VALUE ENGINEERING TEAM STUDY REPORT

Greenup Lock

OHIO RIVER

Sponsored By:
U.S. Army Engineer District, Huntington

DRAWING NO 2:

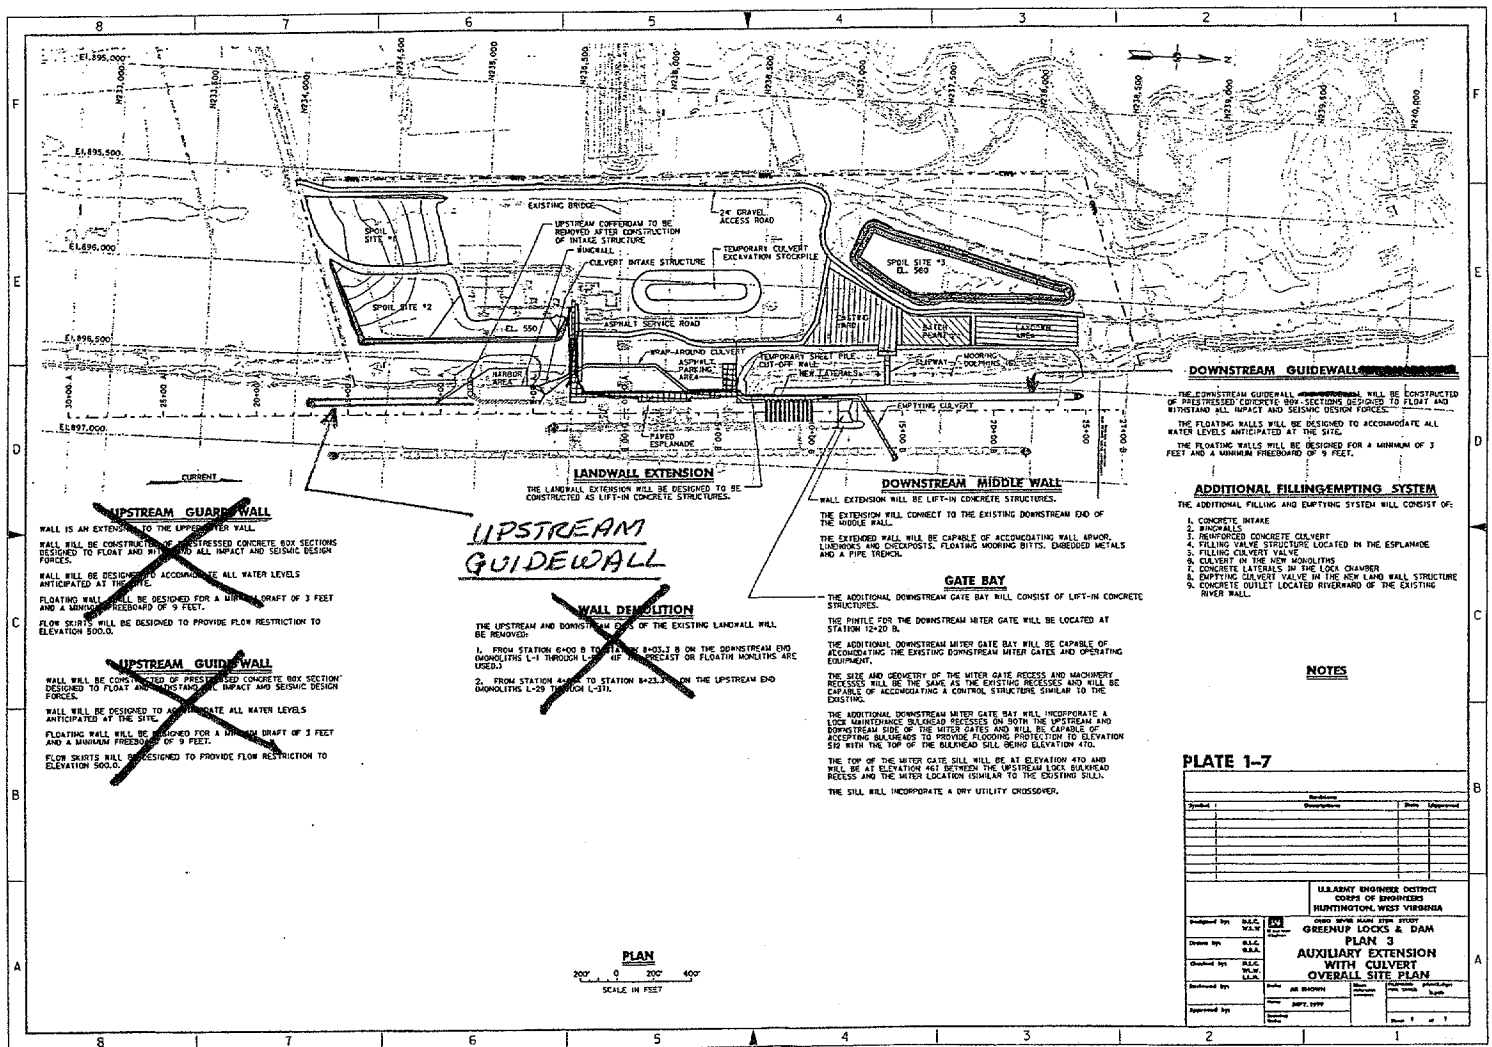
Do not extend upstream riverside guardwall (URW) and upstream middle wall (UMW). Do not demolish existing upstream landside wall. Extend upstream landside guidewall 800 feet. Relocate harbor area farther upstream. (See Drawing No. 2).

DRAWING NO 1:

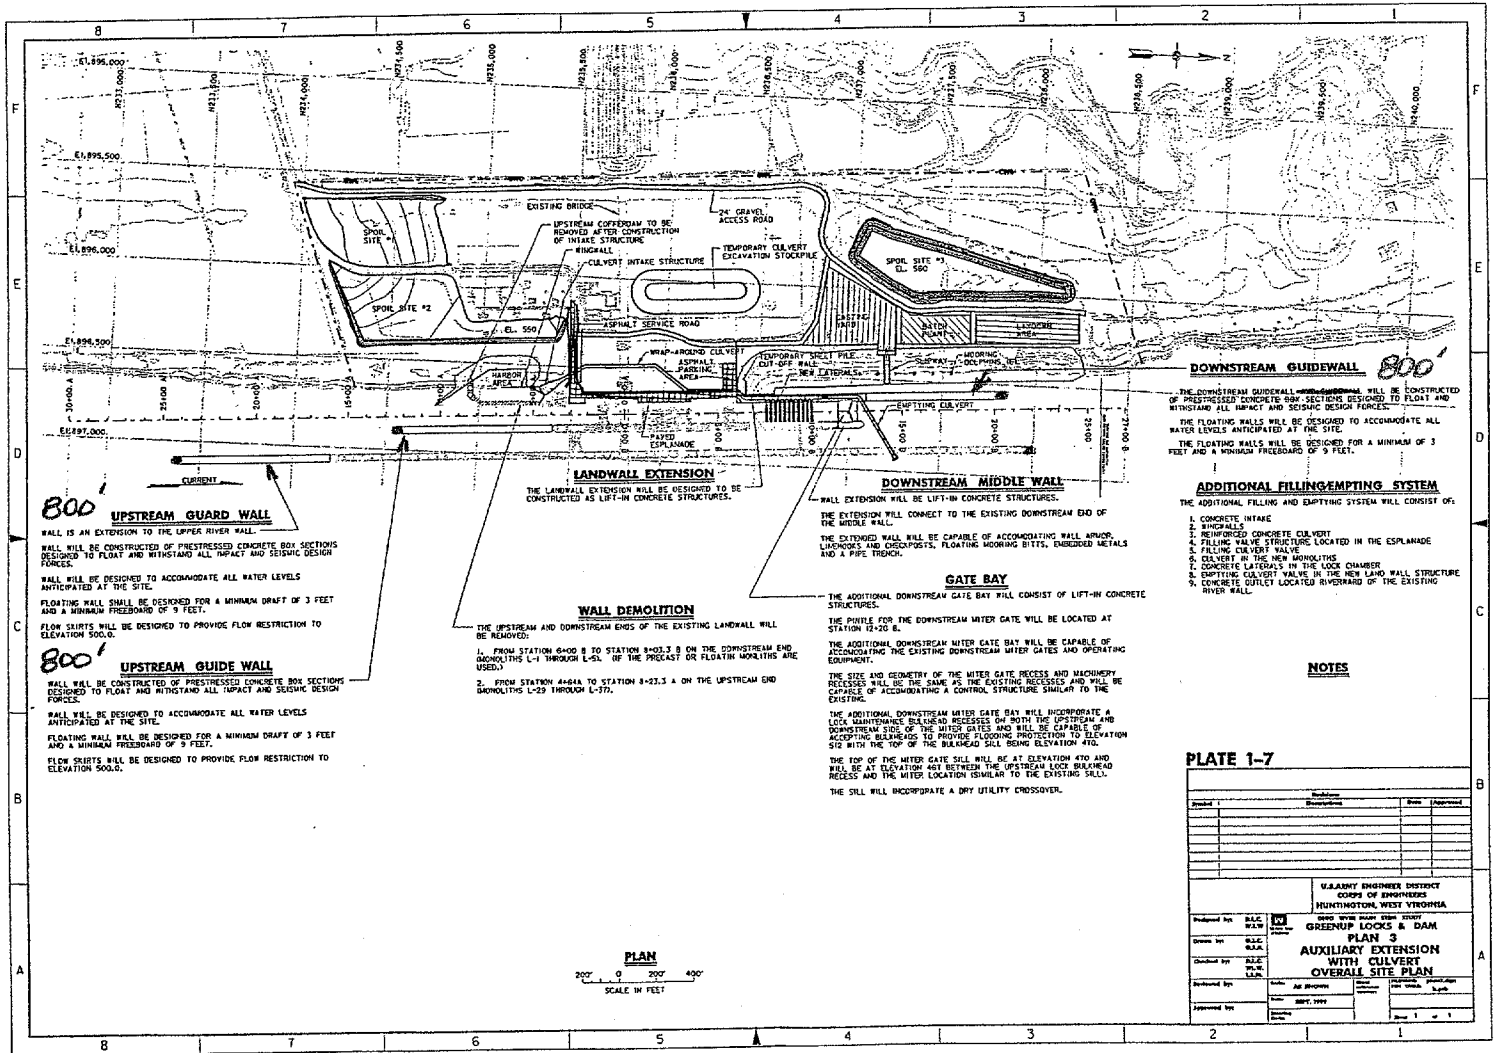
Upstream middle approach wall (UMW) of the extended lock will be increased to 1,200 feet in length to correspond with general guidance for 1,200-foot locks. As a result, the riverward approach wall (URW) for the existing 1,200-foot riverward lock must be extended an additional 1,200 feet as well. Downstream landside approach wall of the extended lock (LLW) will also be increased to 1,200 feet. Riverward guardwall (LRW) will be extended to terminate in parallel with the landward guidewall. (See Drawing No. 1).

Do not extend all guardwalls upstream and downstream by 1,200 feet (reduce lengths to 800 feet for the purpose of this cost comparison). Do not demolish existing upstream landside wall. Relocate harbor area farther upstream. (See Drawing No. 2).

DRAWING NO. 1:

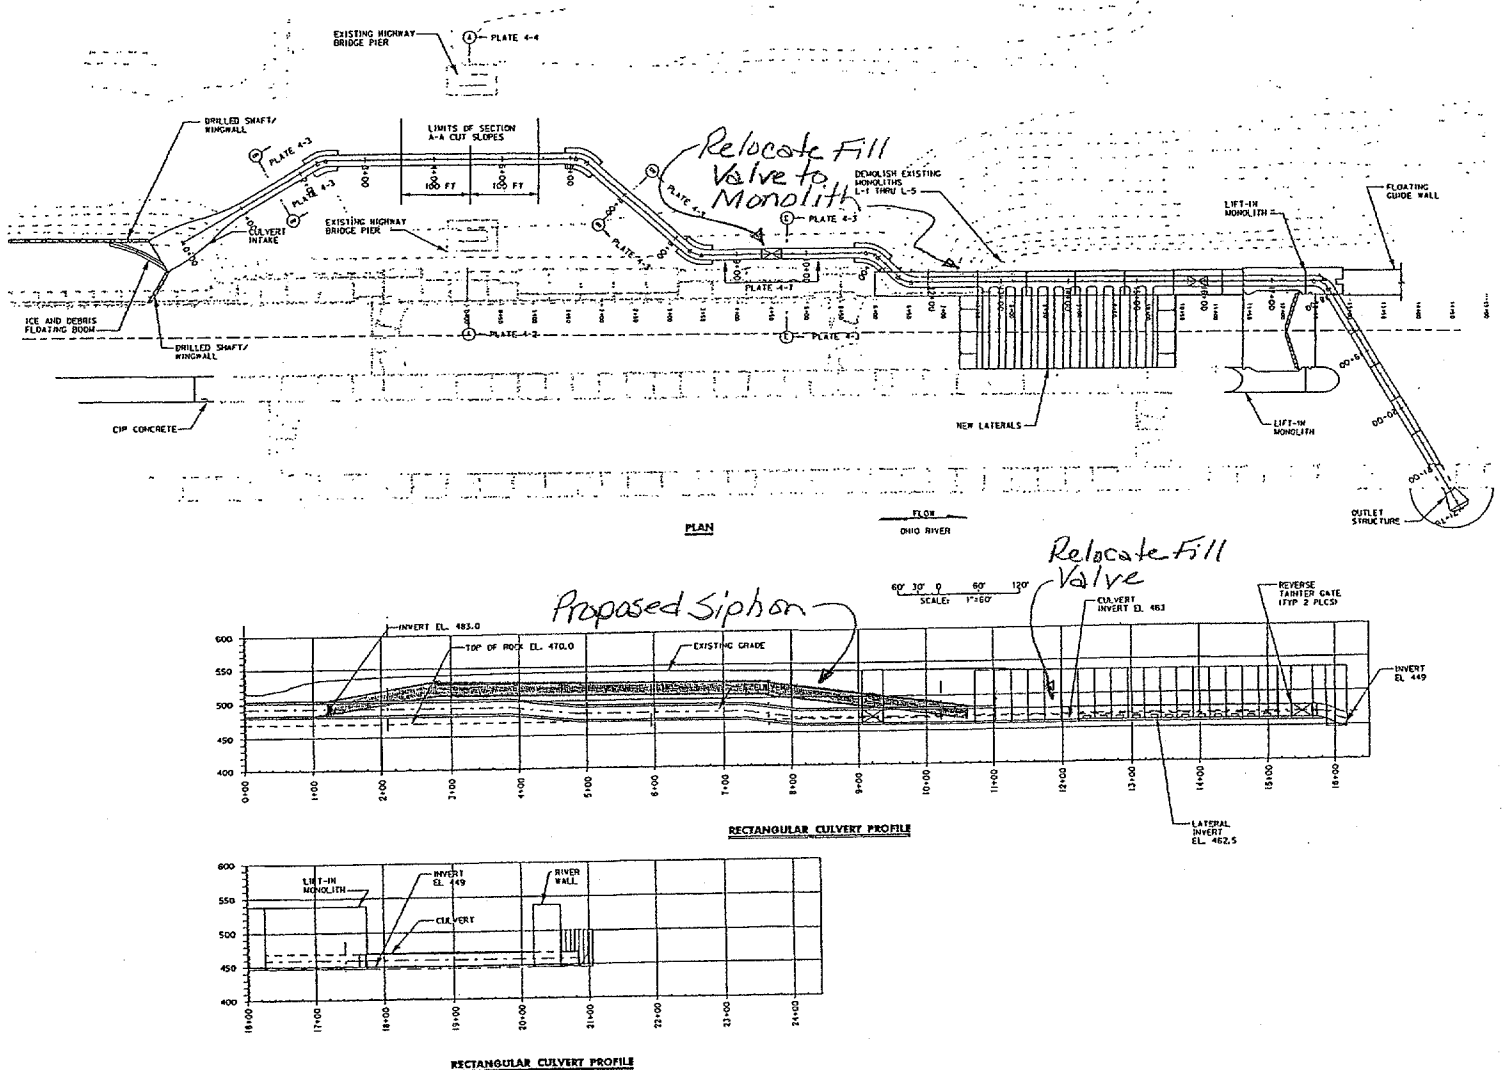
The siphon-culvert would develop following the inflow from the original design intake structure. It would utilize two 12-foot diameter steel pressure pipe lines meeting the intake at depth, then running just beneath the surface, then meeting the culvert valve at depth.

DRAWING NO. 1

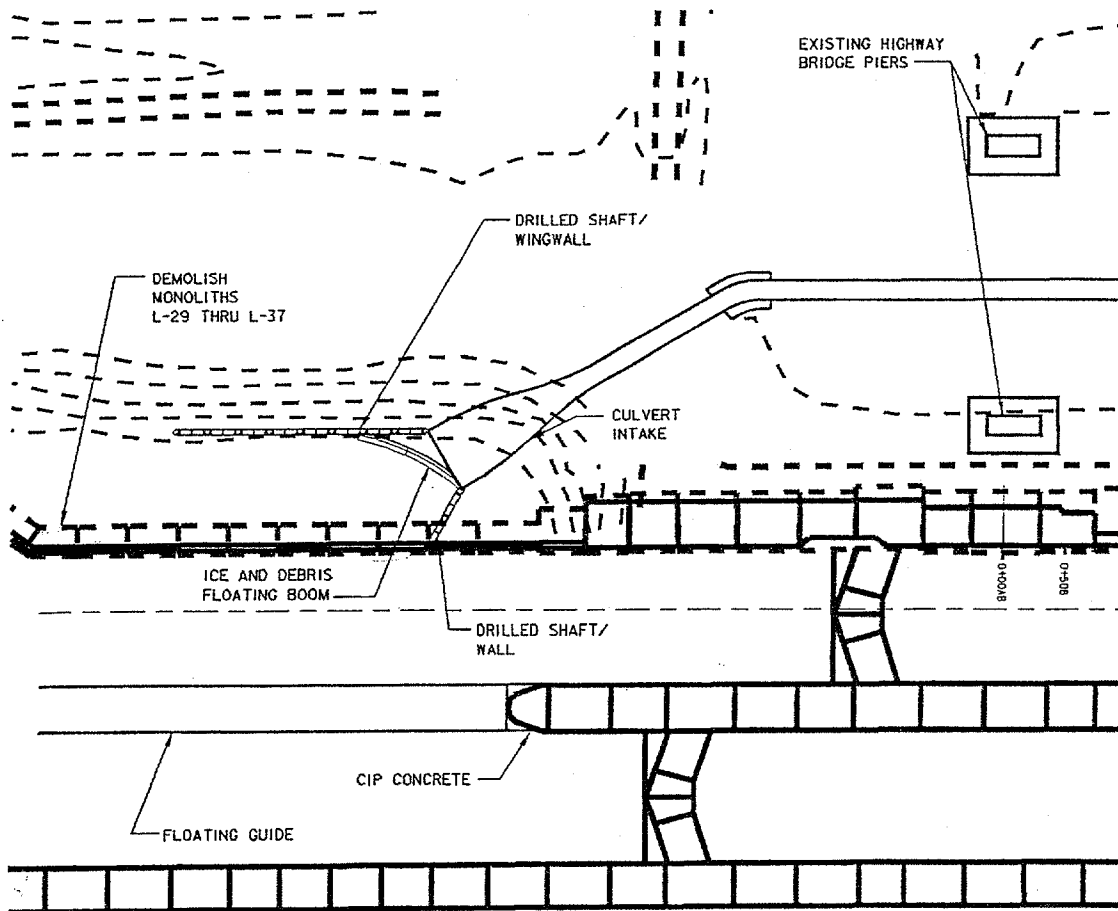
- CALLS FOR WING WALLS AND DRILLED SHAFT WALLS AS SHOWN WITH ICE/DEBRIS BOOM
- DEMOLITION OF MONOLITHS AT L29 - L37 ARE REQUIRED TO SHORTEN THE PROPOSED APPROACH WALL EXTENSION LENGTHS, WHICH REDUCES OVERALL PROJECT COST.

DRAWING NO. 2

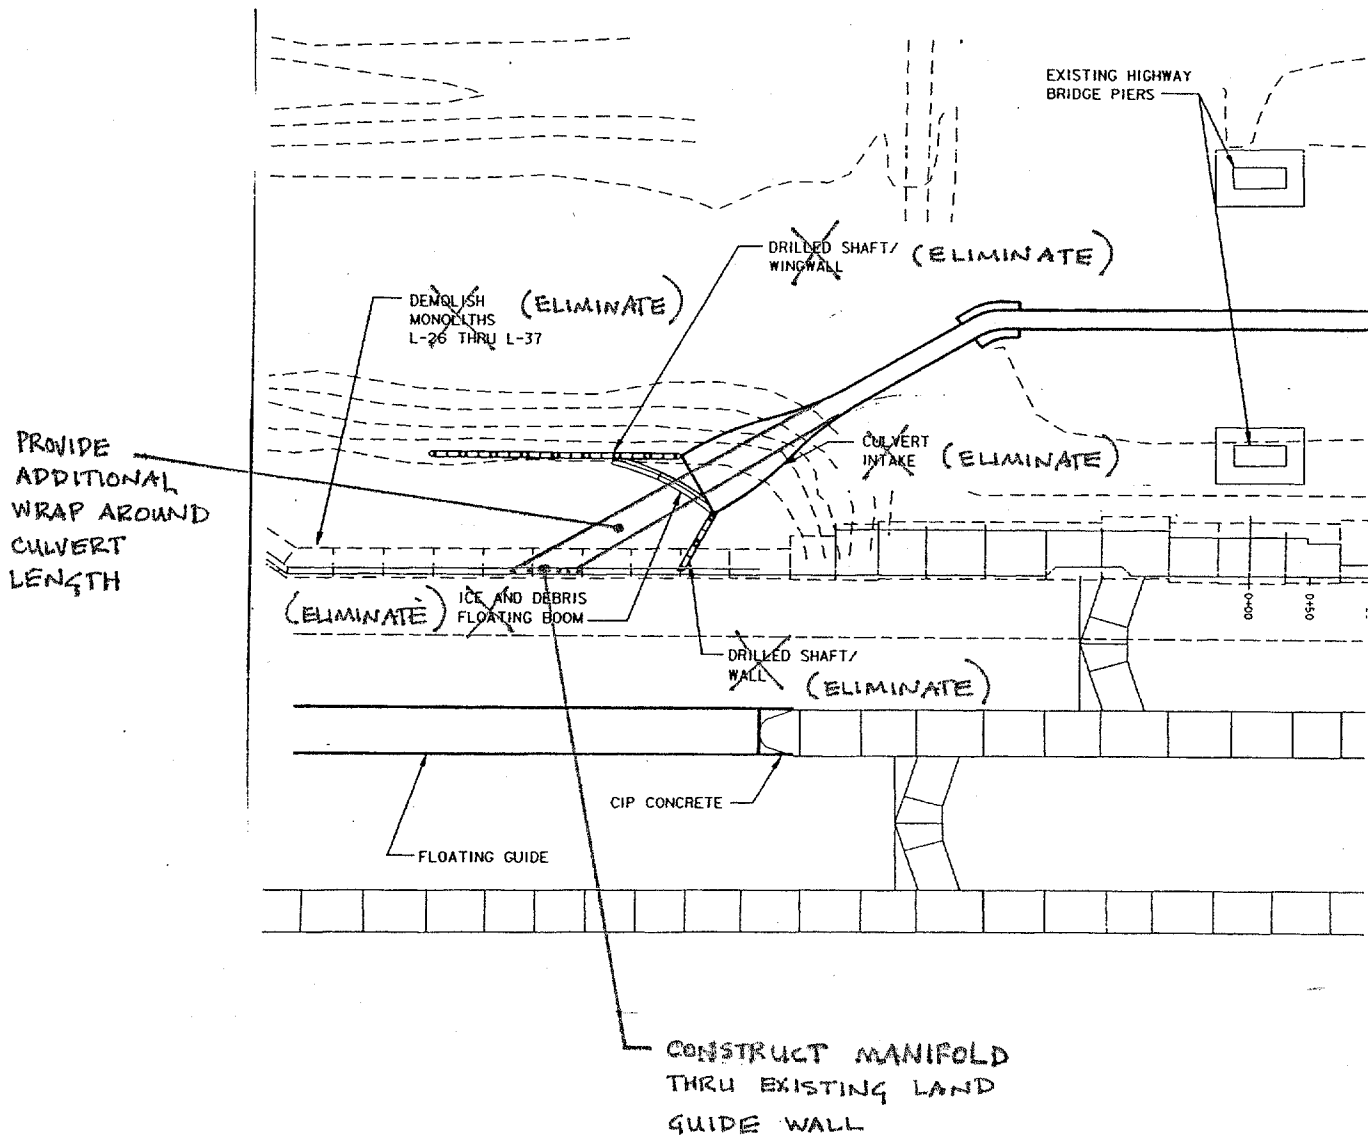
1. Eliminates need for intake and wing wall construction.
2. Eliminates need for debris and ice boom.
3. No demolition of existing upstream guide wall needed if approach wall modifications are included.
4. Leaves area for work boat if existing guide wall are not altered.
5. Modified intake would be well upstream of existing auxiliary intake.

PROPOSED DESIGN WITH CONDUIT BEHIND LOCKWALL

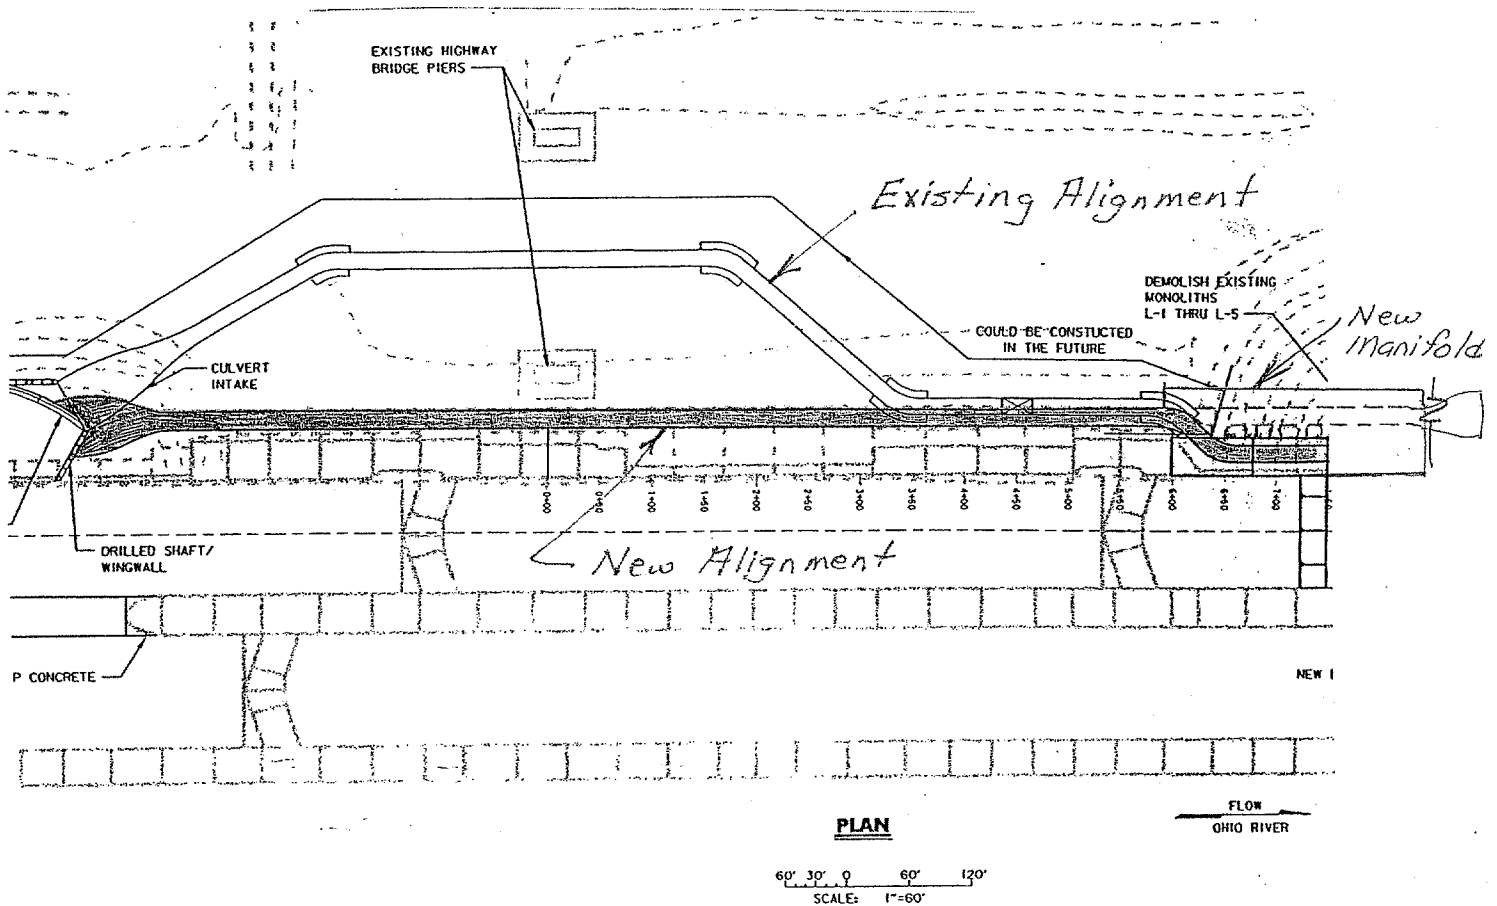
The horizontal alignment of the conduit is adjacent to the lockwall along the entire length. The vertical alignment rises from the intake structure to an elevation needed to pass the bridge pier without interfering with the pile supports for the bridge pier. Change to circular section for conduit.

ALTERNATIVES FOR "FAILED" DRILLED CAISSON LOCK WALL

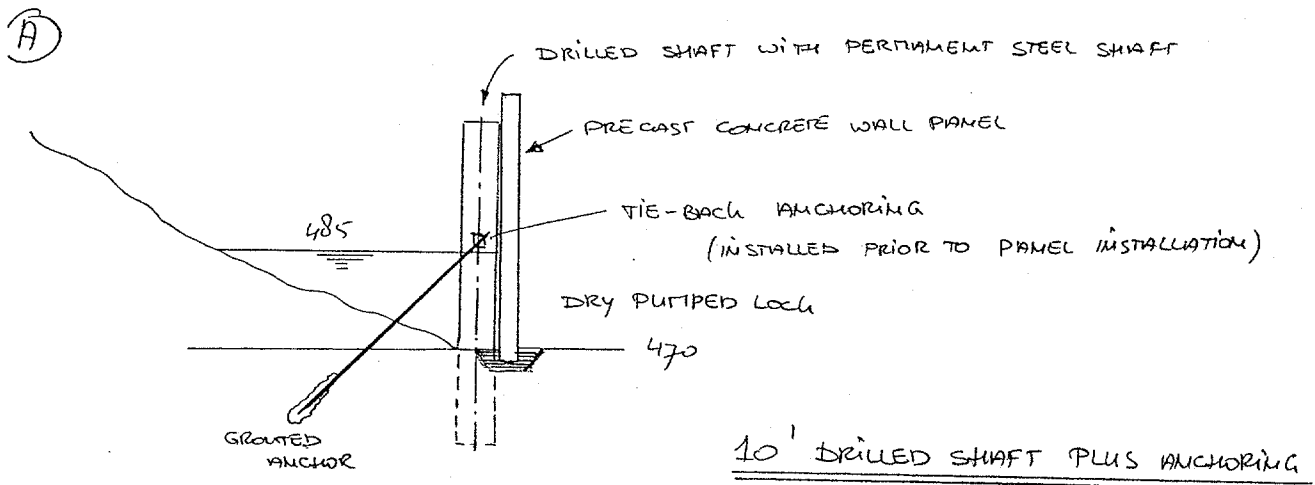
There is a significant savings in concrete when this wall section is adopted. Load on the rock must be carefully considered. Rock strength and P-Y curves could be refined by full-scale testing.

DRAWING NO. 2

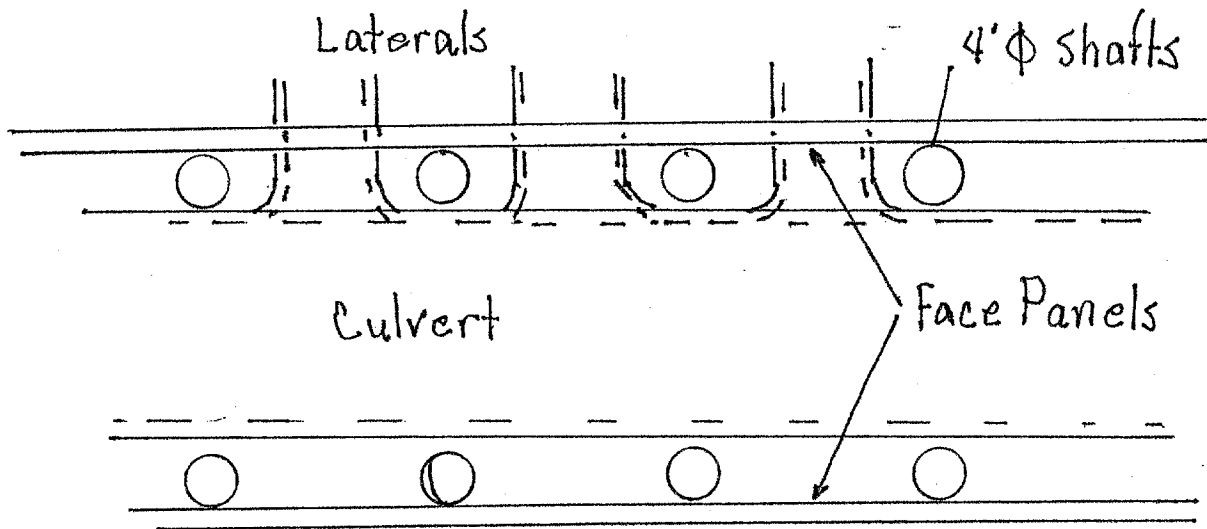
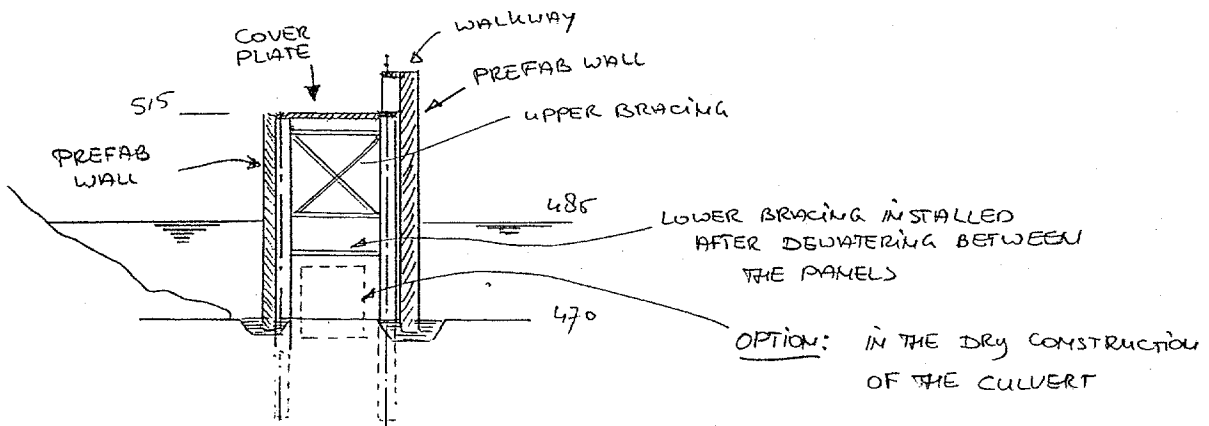
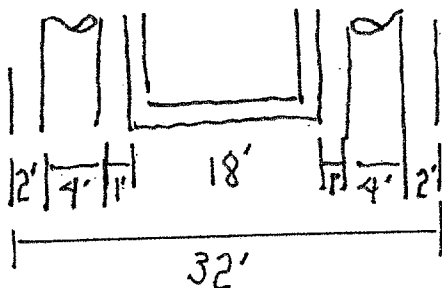
Material is saved and a chamber is created that permits construction of the culvert in the dry. Load is taken into the rock in a more reliable tension compression couple. The 4-foot shafts will be drilled with conventional pier drill rigs.
